CITY OF ALBUQUERQUE

RE: **North Second St Storage**
5124 2nd St NW
Grading Plan Stamp Date: 5/1/18
Drainage Report Stamp Date: 5/2/18
Drainage File: F15D052E

Based on the information provided in your submittal received 5/3/18, the grading plan and drainage report cannot be approved until the following are addressed:

RE: **North Second St Storage**
5124 2nd St NW
Grading Plan Stamp Date: 3/15/18
Drainage Report Stamp Date: 3/14/18
Drainage File: F15D052E

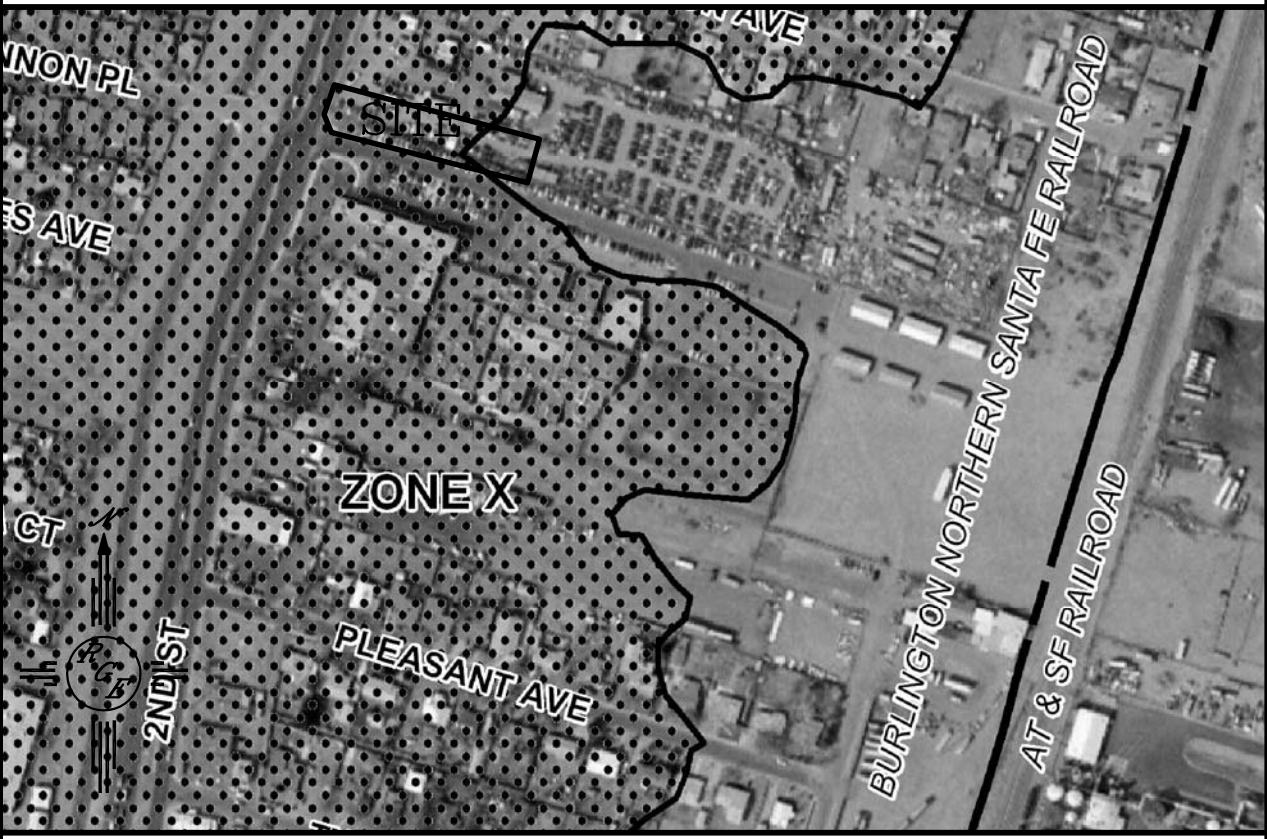
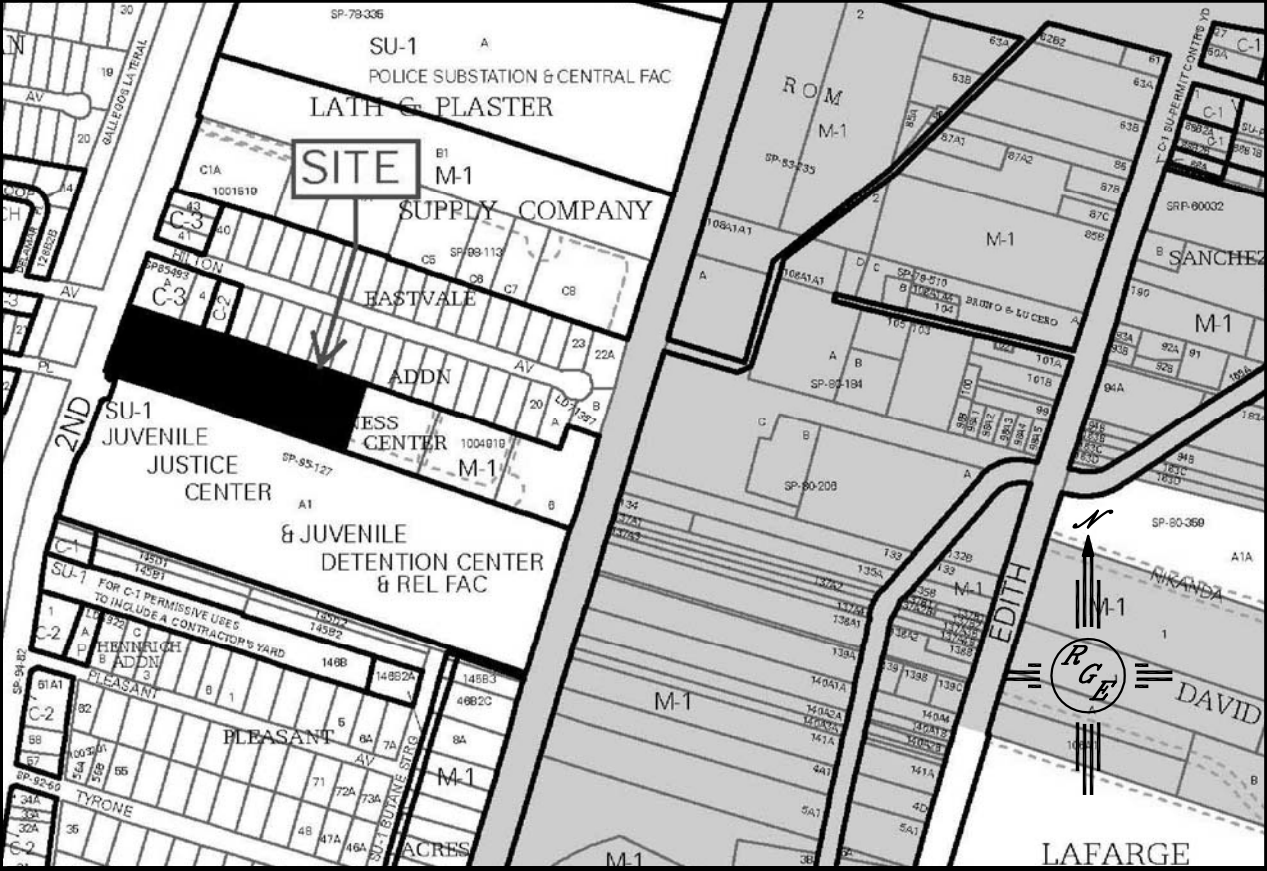
2. This project requires an ESC Plan, submitted to the Stormwater Quality Engineer (Curtis Cherne PE, ccherne@cabq.gov or 924-3420).
3. Show on plans where the emergency spillway from the storage units is; provide a section of this with elevations and dimensional data. Provide hydraulic calculations to demonstrate that it can pass the 100-yr peak flow without flooding the storage units.

4. Correct the grading plan and notes to show construction of (3x) 2' sidewalk culverts.
corrected
5. The subbasins map appears to be overlaid on a previous iteration of the grading plan where stormtechs were employed. Please update this underlay to avoid confusion.
updated
